## **Response to Comments**

### **Master Plan Update Improvements at Seattle-Tacoma International Airport**

*Permit: 1996-4-02325*

April 2001

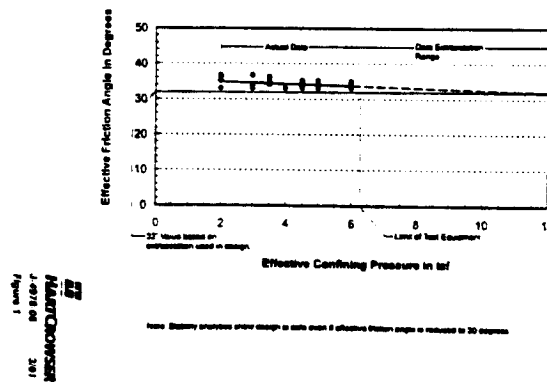
A close examination of the stress-strain curves in both the CU and UU triaxial tests indicates that 14 of the 37 soil samples (about 38%) showed higher shear strength at 20% strain than at 10% strain. The other soil samples showed either the same or slightly lower shear strength values at 20% strain compared to 10% strain. The difference in shear strength values at 10% and 20% strain is generally less than 15% and has already been taken into account in the Port's design. Running the tests to 20% strain demonstrates there is no significant reduction in strength as strain increases. This demonstrates the soil can tolerate large deformations without failure and any increase in strength means it will further limit deformations.

The design strength values of soils were selected based on the laboratory test results, as well as consideration of the field cone penetration test (CPT) data. The undrained shear strength of soils interpreted from UU triaxial tests correlates reasonably well with CPT results (*Kulhawy, F.H. and Mayne, P.W. (1990), Soil Property Manual, Electrical Power Research Institute, EPRI Report EL-6800*). The selected design strength values of soils for the stability analysis and design of the MSE walls were typically lower (more conservative) than those interpreted from laboratory and field test results. For example, values of undrained shear strength used in the West Wall stability analyses were 1,000 pounds per square foot (psf) for the soft to medium stiff silt and clay, and 3,500 psf for the stiff to hard silt and clay, while actual UU strength values from samples at the West Wall location ranged from over 1,300 to almost 9,300 psf.

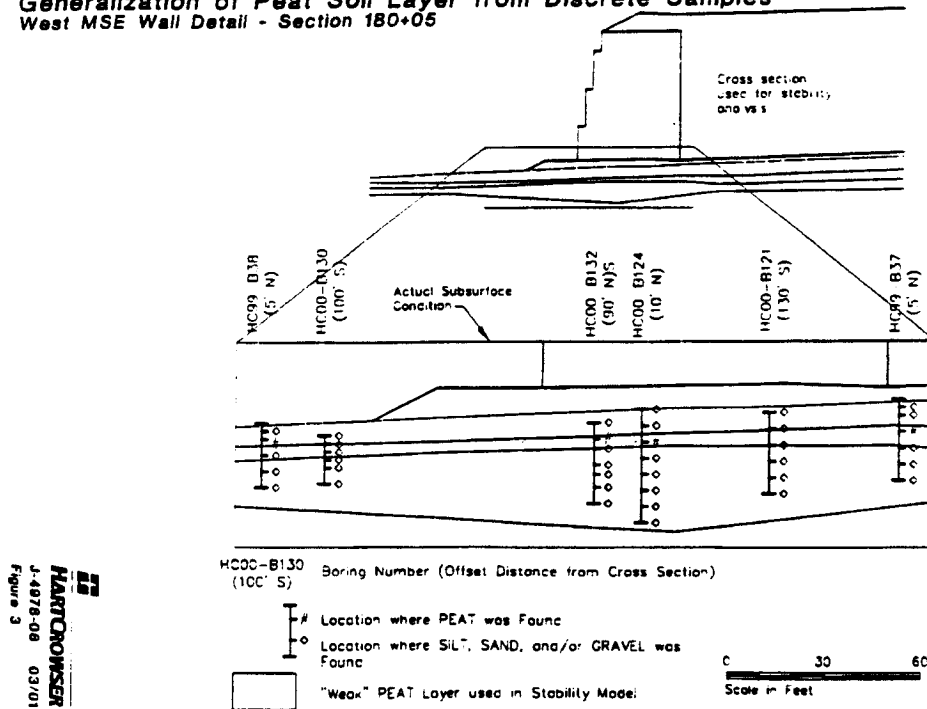
The comment asserts that the Port's pseudo-static (seismic) stability analysis is improper, and that a more "proper" analysis should be performed to search for the critical failure surface independently of the static analysis. However, it is the Port's belief that there is no theoretical justification, or code requirement that justifies the suggested approach. The pseudo-static approach used by the Port represents the standard of practice for this type of analysis. Searching for a critical surface with the pseudo-static acceleration

component included in the search is unreasonably overly-conservative, and for this reason is not required by design standards such as the code developed for design of MSE walls by the American Association of State Highway and Transportation Officials (*AASHTO, 1996-2000 "Standard Specifications for Highway Bridges", 16th Edition, 1996, with current interim addenda through 2000*) and the Federal Highway Administration (*FHWA, 1997, Mechanically Stabilized Earth Walls and Reinforced Soil Slopes Design and Construction Guidelines, SA-96-071*).

The Port recognizes that there are inherent limitations in the use of any pseudo-static, limit equilibrium type analysis to assess stability of slopes and MSE walls. The Port's engineers have addressed seismic stability recognizing the limitations in the pseudo-static method through the use of appropriate design parameters and factors of safety; use of post-liquefaction stability analyses, and in part by using a completely different approach (finite difference based deformation analysis) to provide an independent assessment of seismic stability.
